TECHNICAL BULLETIN

Momentary Engine Power Loss or Stalling Diagnosis and Repair

18-38

MODEL **91-94 4.0L Sedans**
93-94 4.0L XJS

DIAGNOSTIC CHART: SYMPTOM - MOMENTARY LOSS OF ENGINE POWER, OR STALLING - ENGINE RESTARTS IMMEDIATELY.
 USE THE FOLLOWING CHART TO FIND AND CORRECT THE CAUSE. PERFORM EVERY STEP WHETHER OR NOT A FAULT IS FOUND.

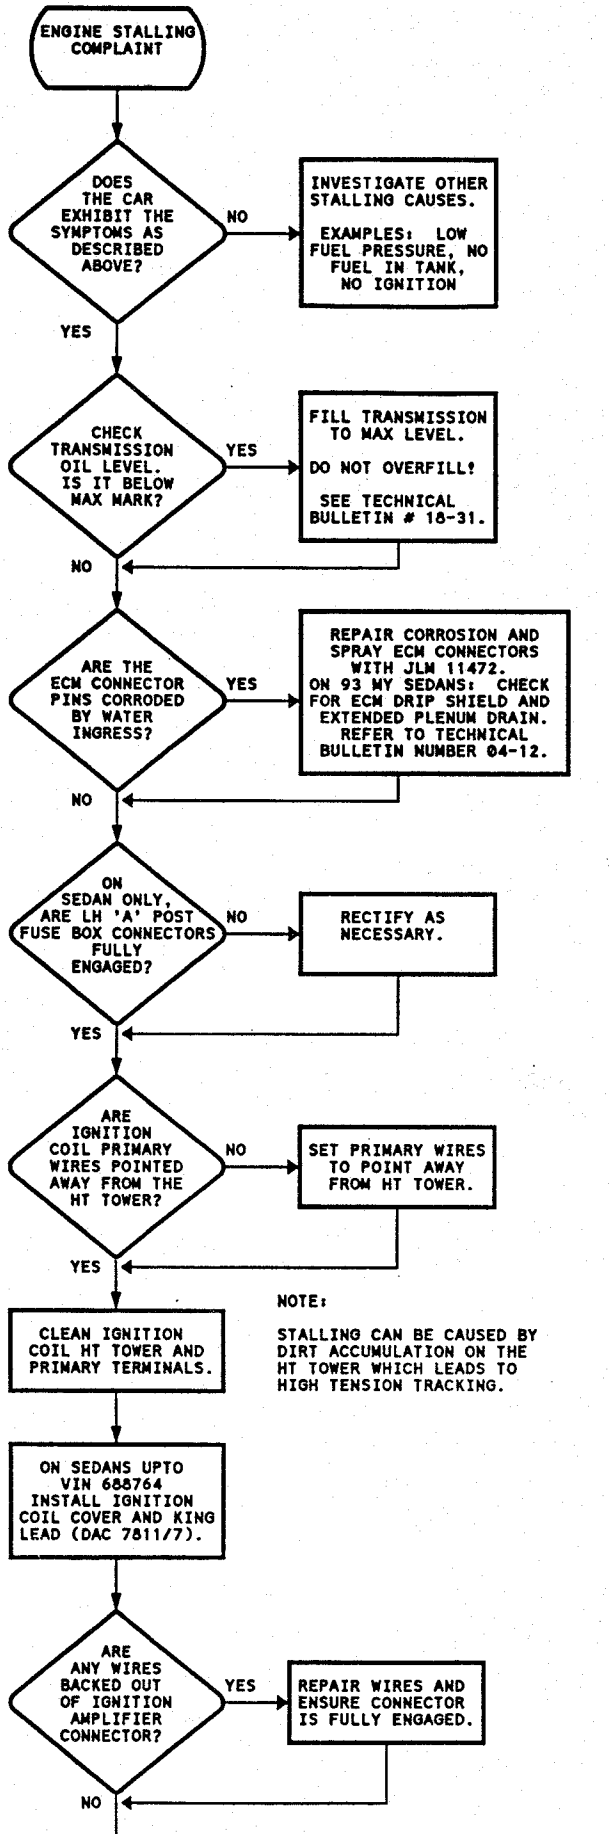
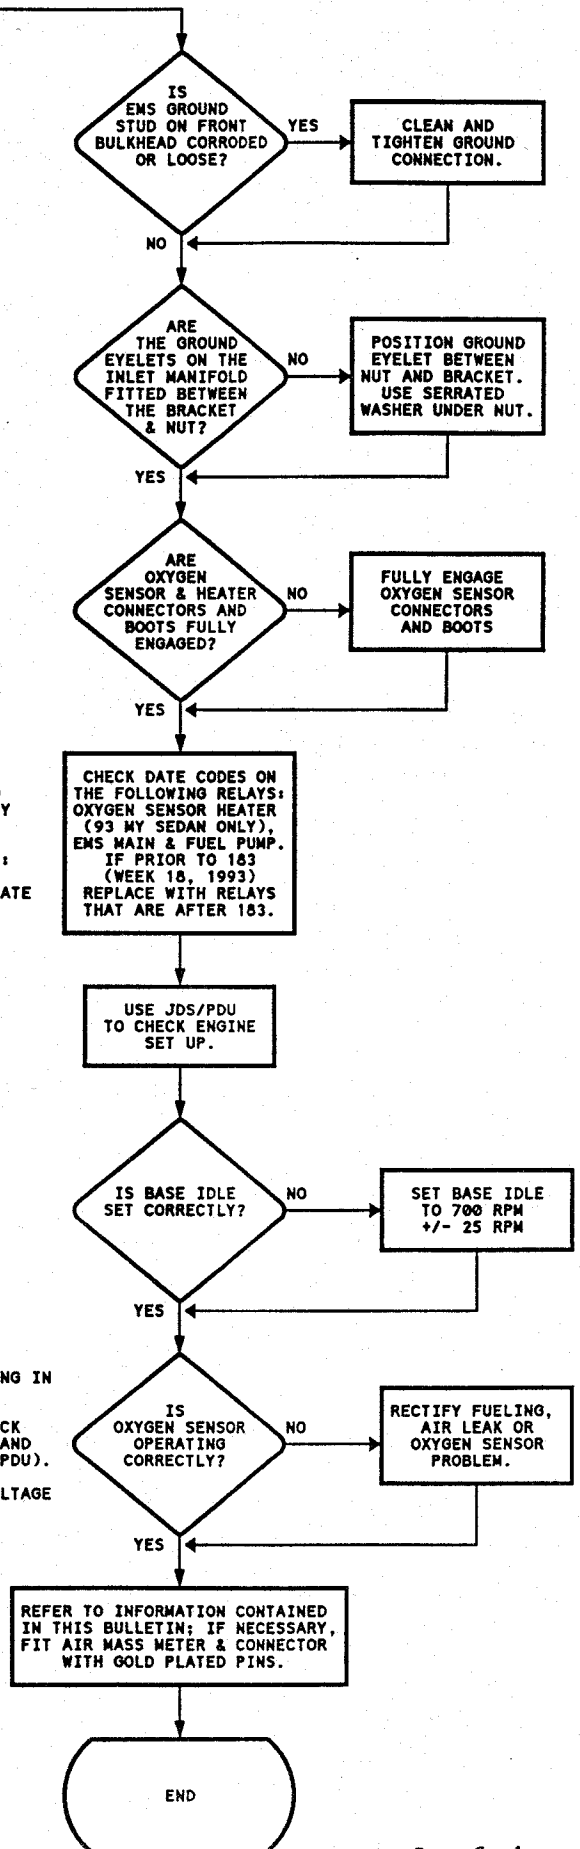
For complaints of momentary engine power loss and/or stalling (engine restarts immediately), work through the attached Diagnostic Chart to find and correct all possible causes. Perform every applicable step, whether or not a fault is found.

THIS STEP APPLIES TO HELLA RELAYS ON 93 MY VEHICLES ONLY.

FOR RELAY DATE CODES: FIRST 2 DIGITS INDICATE WEEK.

LAST DIGIT INDICATES YEAR.

STALLING CAN BE CAUSED BY DIRT ACCUMULATION ON THE HT TOWER WHICH LEADS TO HIGH TENSION TRACKING.

OXYGEN SENSOR FEEDBACK SHOULD BE BETWEEN 1 AND 4 VOLTS (USE JDS OR PDU).

OXYGEN SENSOR RAW VOLTAGE SHOULD SWING BETWEEN 0.2 AND 0.8 VOLTS.
